**AGENDA
PLANNING & ZONING COMMISSION
THURSDAY, November 14, 2019
7:00 P.M. TOWN HALL**

TITLE: Continued Public Hearing - Sopris Lofts – 1201 Colorado Avenue
Major Site Plan Review, Conditional Use Permit, Alternative Compliance
and an Amendment to Ordinance No. 18, Series of 2016

LU19-20-20 Stein 133 and Main - Major Site Plan Review - RESPONSE

TITLE: Sopris Lofts – 1201 Colorado Avenue
Major Site Plan Review and Conditional Use Permit

EXHIBIT 1

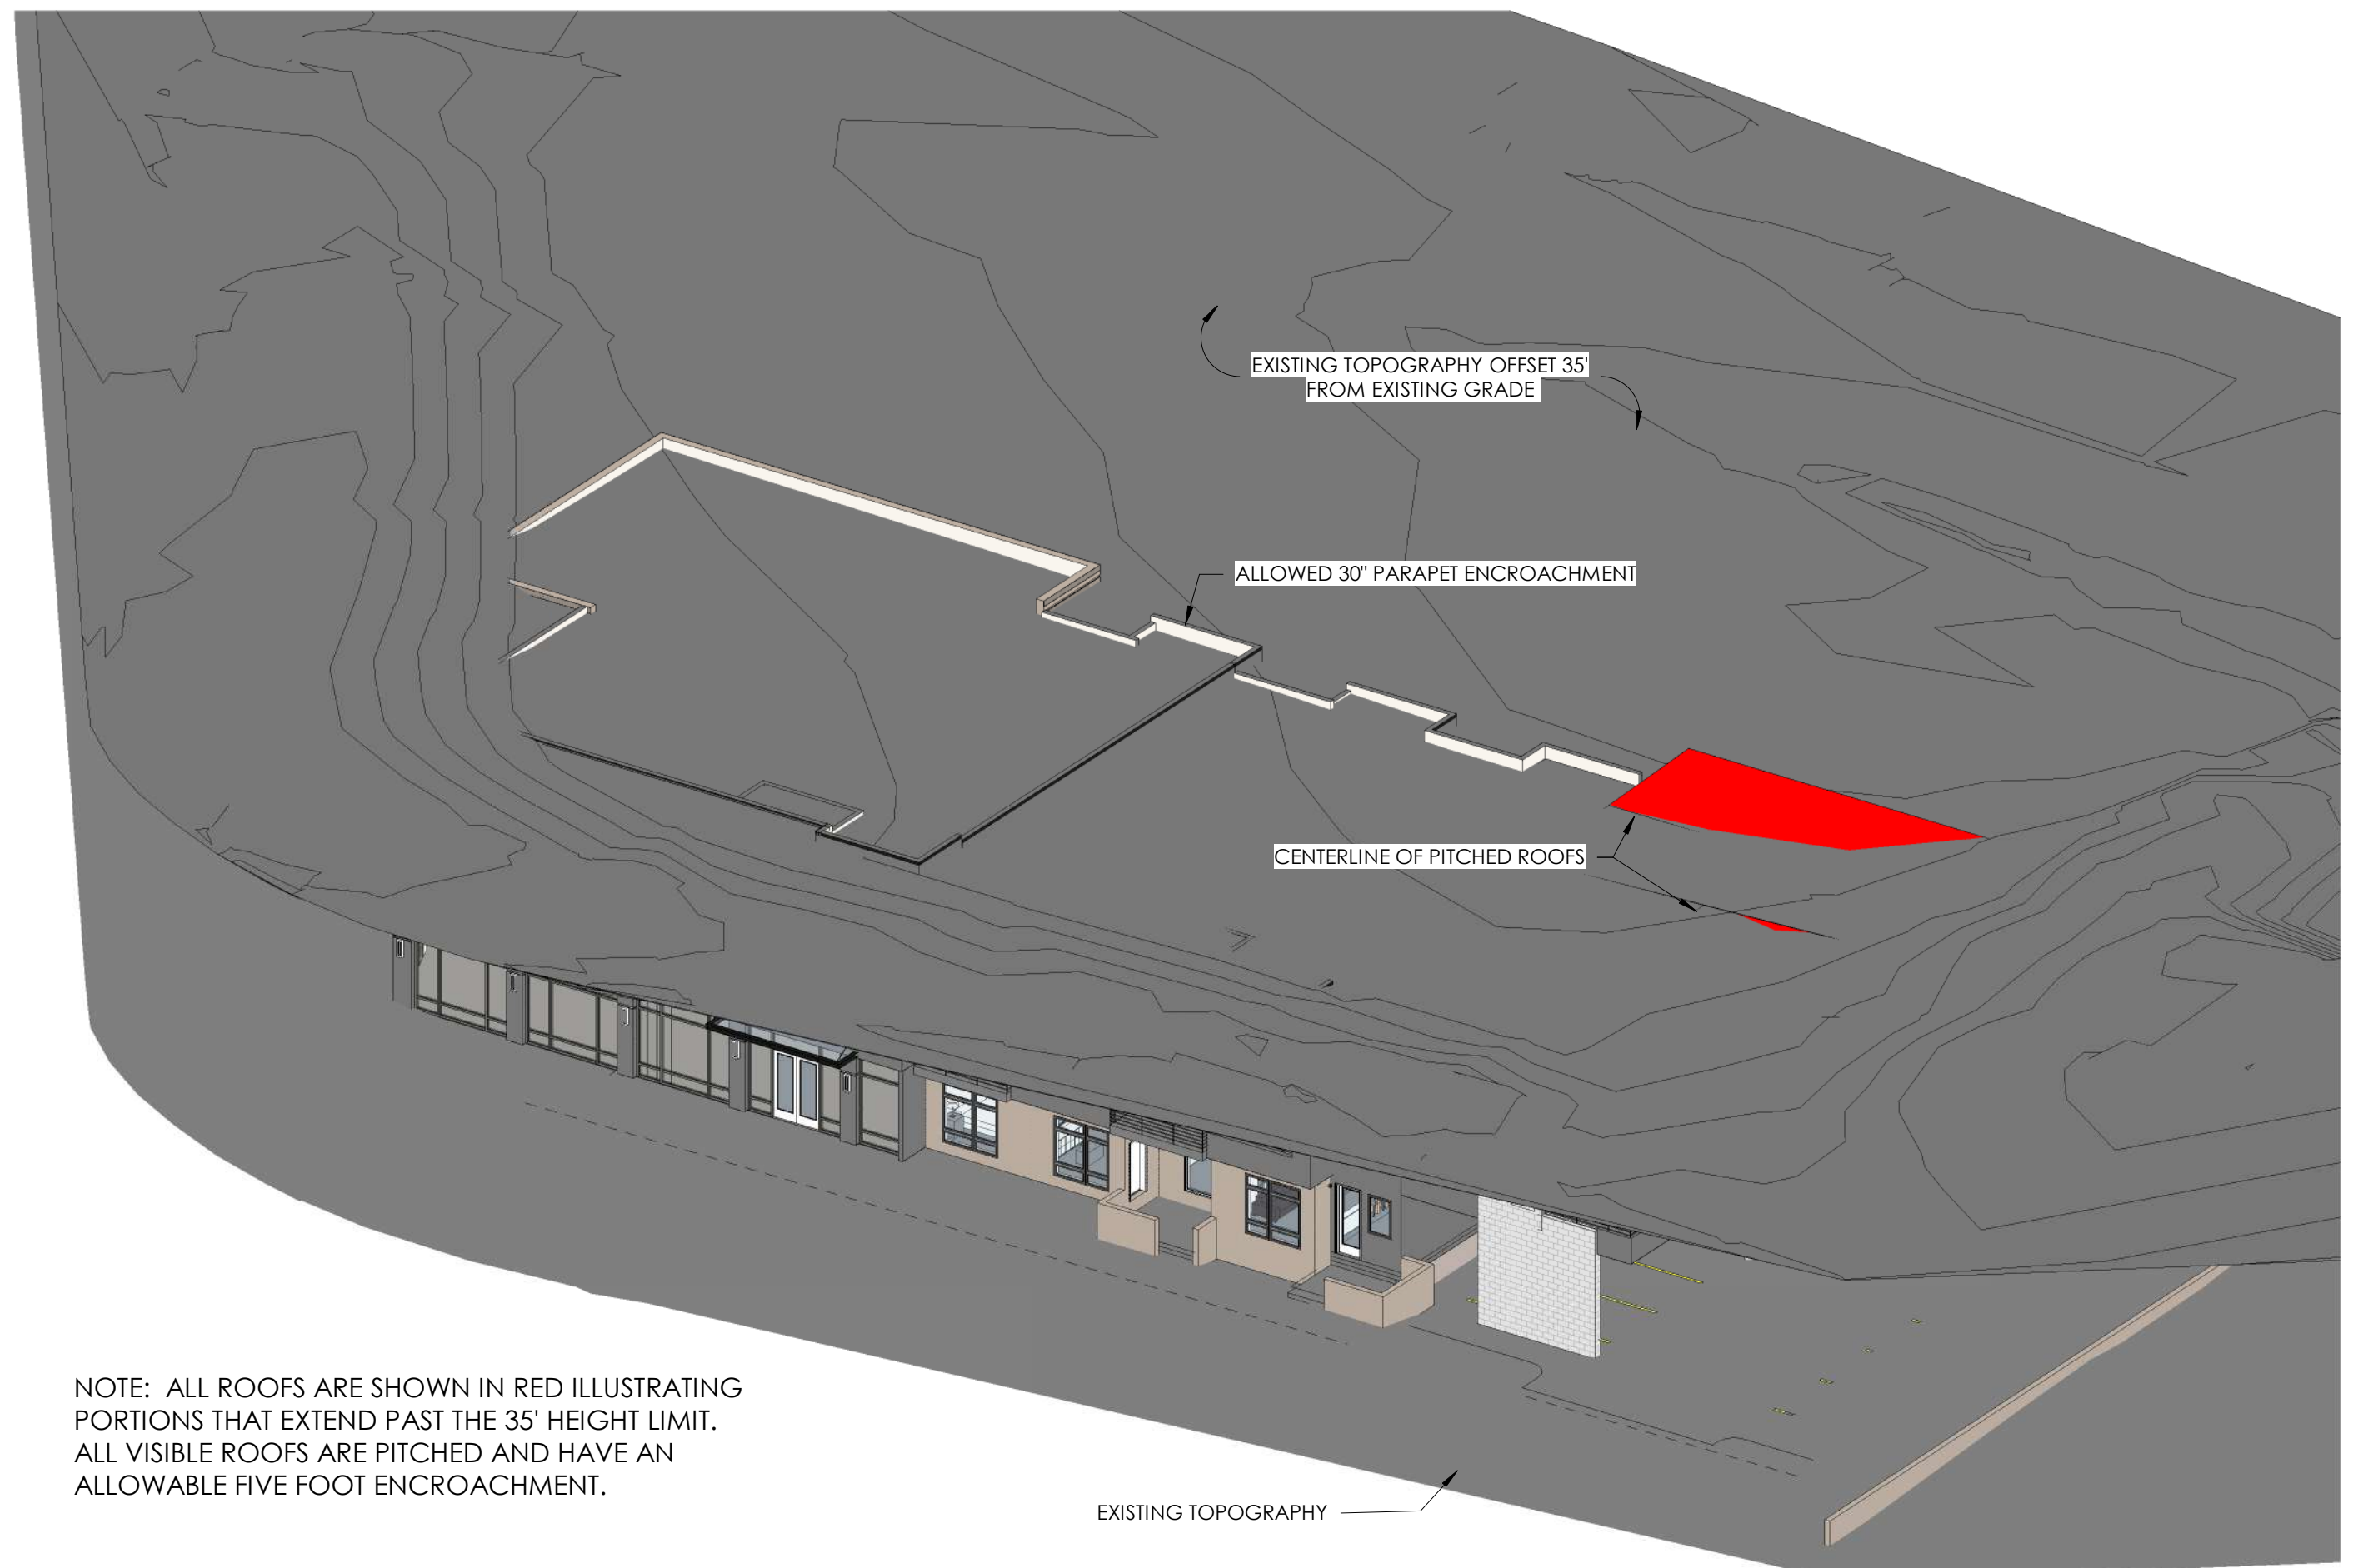
The allowed building height in the MU zone district is 35 ft. An additional 30" is allowed for parapet walls. Rooftop mechanical equipment can exceed the height by 5 ft. Because of the grade of the site, this has been a challenging issue; however, the elevations on Sheet A4.01 show that the building meets the allowed maximum building height.

The roof levels on the elevations illustrate the top of the roof sheathing. We created an additional 3d diagram, (Exhibit 1) which shows the existing topography offset 35' to show the height restriction at every point on the site. Sopris Engineering produced the topography surface based on the site survey. All protrusions in the topography surface illustrate parapet walls or pitched roofs—none of the flat roof portions are visible indicating that they are below the height limit. The center line of pitched roofs is called out to illustrate compliance.

EXHIBIT 2

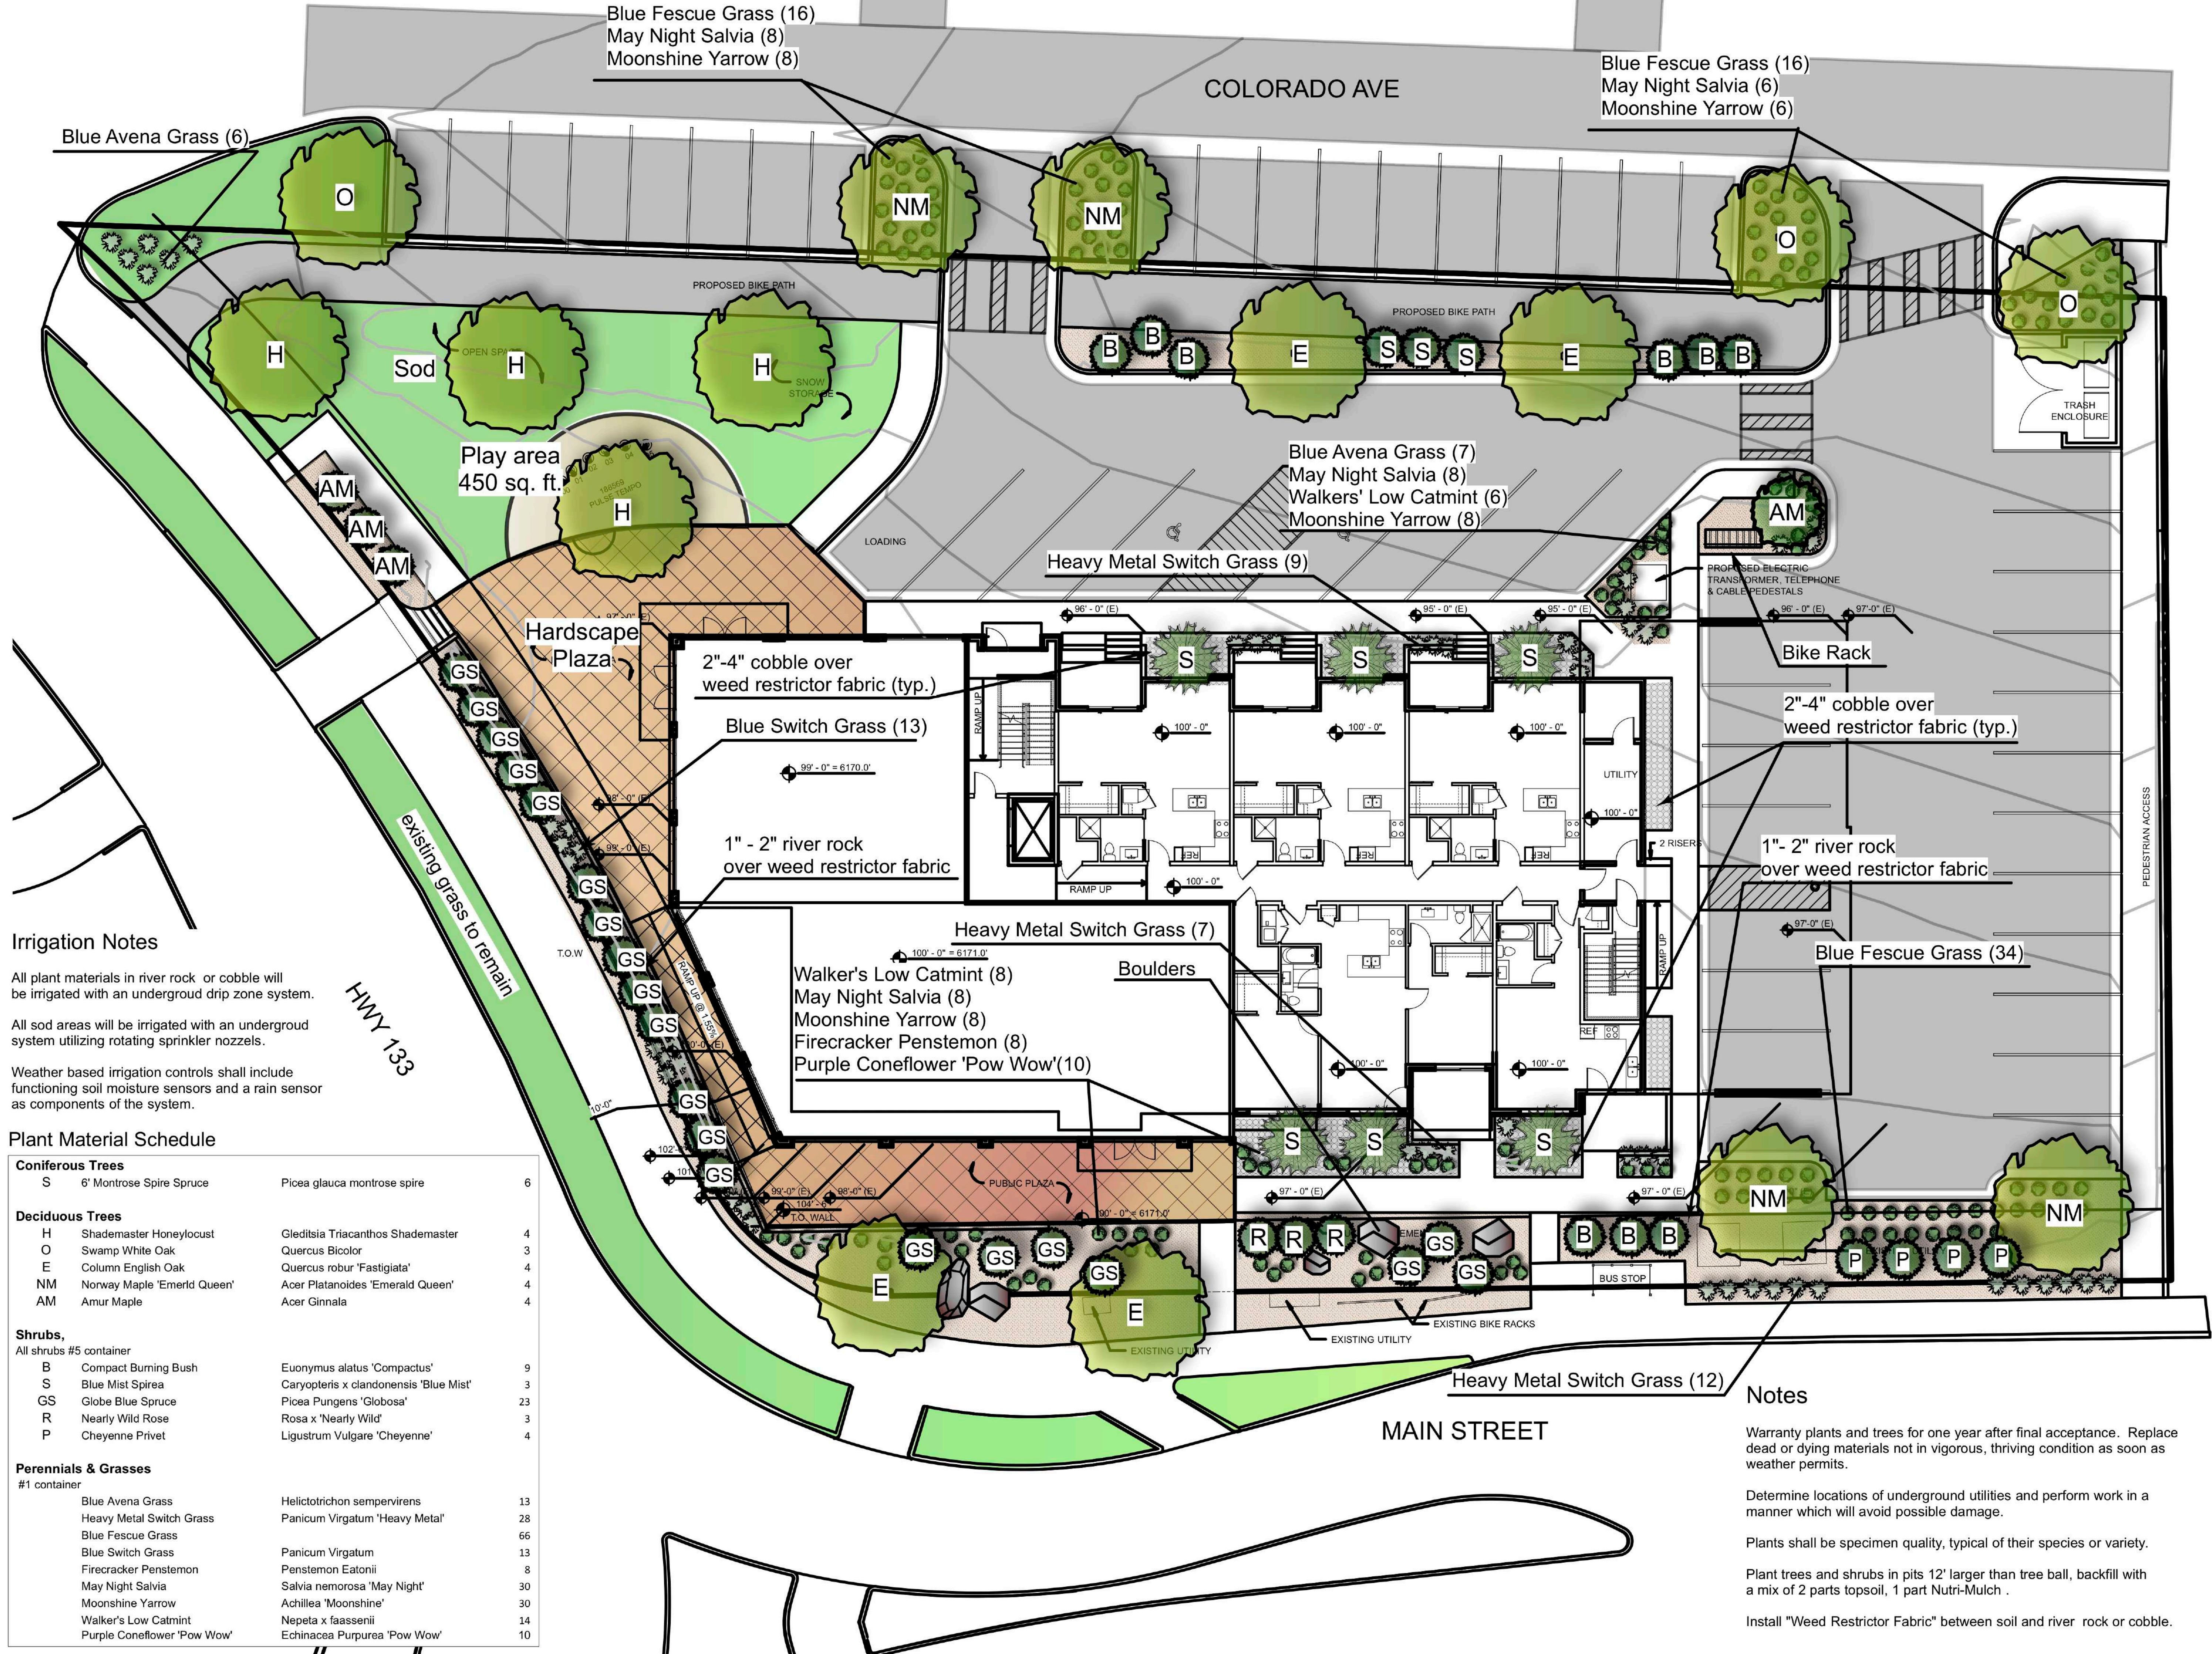
UDC Code Section 5.3.3.F.6 requires a child's play area which is a minimum of 400 sq. ft. or 1% of the required open space whichever is greater. A proposed play area is located to the northwest corner of the building. The plans do not indicate the square footage of this area or any type of play equipment. The play equipment should be ADA and fall-attenuation compliant. This information should be provided.

The Tree Board reviewed the Landscape Plan. Overall, they recommended approval; however, they requested some changes to the landscaping.

- The two (2) Honey Locust within the turf area shall be planted a minimum of 10 feet away from the edge of the existing concrete path. This is intended to maintain pedestrian access and design consistency throughout the corridor.

- The 4-foot planting strip, for the two trees adjacent to the building, is not sufficient space for a tree that will eventually grow to have a 30'-40' canopy spread at maturity. The Tree Board suggests a hedge row to help provide a vegetative buffer. There shall be a minimum 10' planting area for all trees planted within the public right-of-way.

- Other concerns regarding these four trees is trail user/tree conflicts and tree/utility/infrastructure conflicts resulting in damage. To be consistent with the Highway 133 corridor, the trees in the turf area, on the northwest corner, shall be planted 10' from the edge of concrete.

- Compacted crusher fines do not provide an adequate growing medium for the plant material located on the site and within public right-of-way. The Tree Board requests that shrub/perennial beds are mulched. If there are areas where crusher fines must be used, a minimum 10' mulch ring around trees and 4' mulch ring around shrubs shall be used.

- Increase public access to bus stop. Pedestrians will cut from the southeast corner of the building to the bus stop. It may be beneficial to provide access from that area, so shrubs/plant material isn't jeopardized.

This was discussed in the P&Z meeting. They recommended outdoor active equipment that would blend in well with the site. An example of this is provided. P&Z also requested the play area be moved slightly to the east which has been done. The play area will be 450 SF and has been labeled on the Landscape Plan. Refer to Exhibit 2 for an updated Landscape Plan.

The Landscape/Irrigation Plan has been revised to reflect grass/turf in this area. Refer to Exhibit 2 for an updated Landscape Plan.

The Landscape/Irrigation Plan has been revised to reflect the updated locations of the Honey Locust 10' away from the edge of the path.

The Landscape/Irrigation Plan has been revised to reflect a row of ornamental bunch grasses and coniferous shrubs in this area.

The Landscape/Irrigation Plan has been revised to reflect the updated locations of trees in this area at 10' away from the edge of pavement.

The Landscape/Irrigation Plan has been revised to reflect English Oak trees in this area.

The Landscape/Irrigation Plan has been revised to reflect 1"- 2" river rock mulch over weed restrictor fabric for the shrub/perennial beds. This small cobble mulch will not be compacted to allow for root growth into the soil beneath the cobble.

The Landscape/Irrigation and Site Plans have been revised to reflect a path from the southeast corner of the building to the bus stop on Main Street.

1 MECHANICAL CROSS SECTION
1/8" = 1'-0"

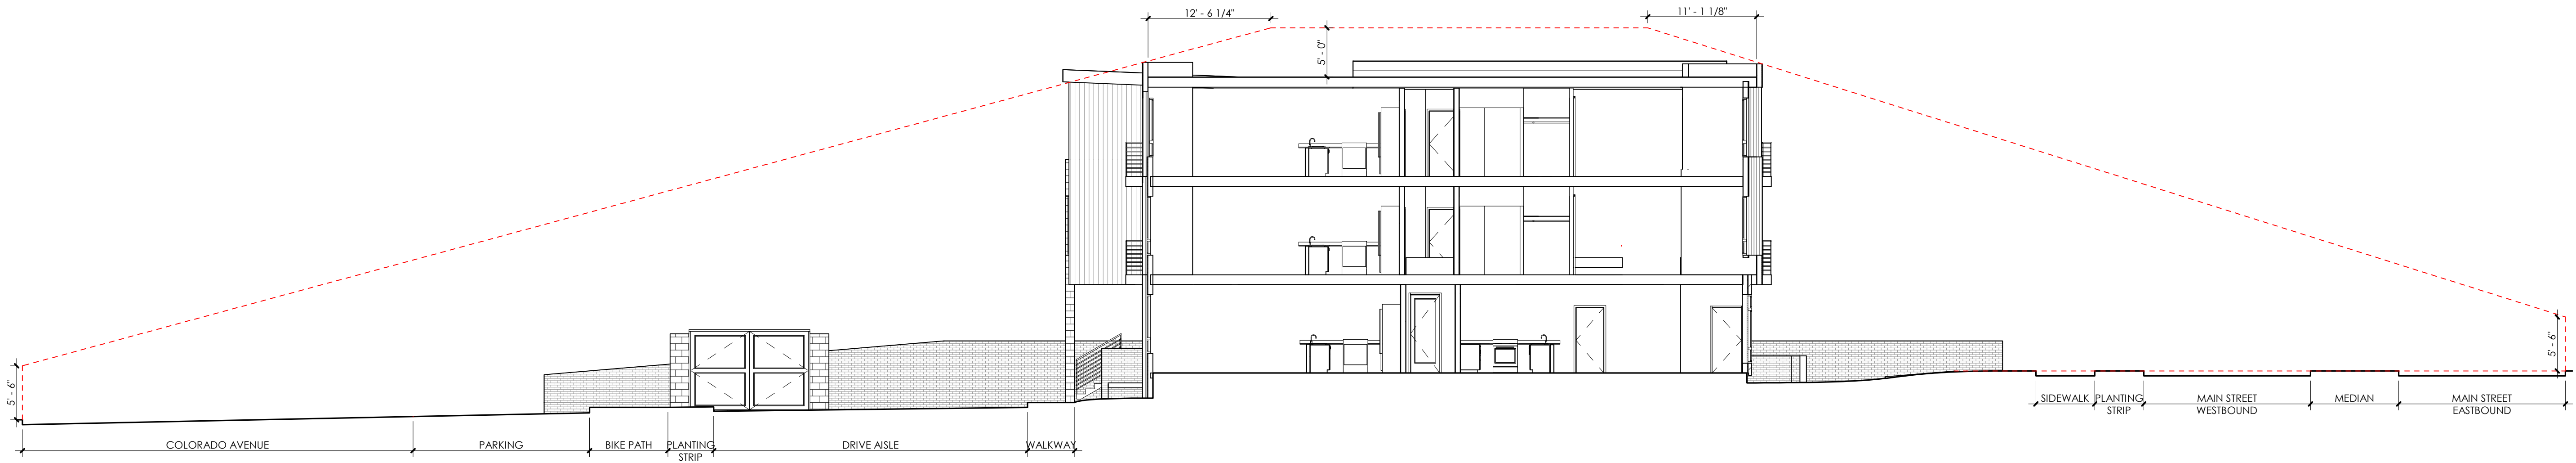
Section 5.4.5.B.1. – This code section states all roof-mounted mechanical equipment shall be screened from the view of a person standing on the property line of the far side of an adjacent street public street. Individual screening of mechanical equipment is prohibited. The plans do not show the solar panel and mechanical equipment. There should be a cross section from the south side of Main Street and from the north side of Colorado Avenue to demonstrate that the equipment would be adequately screened.
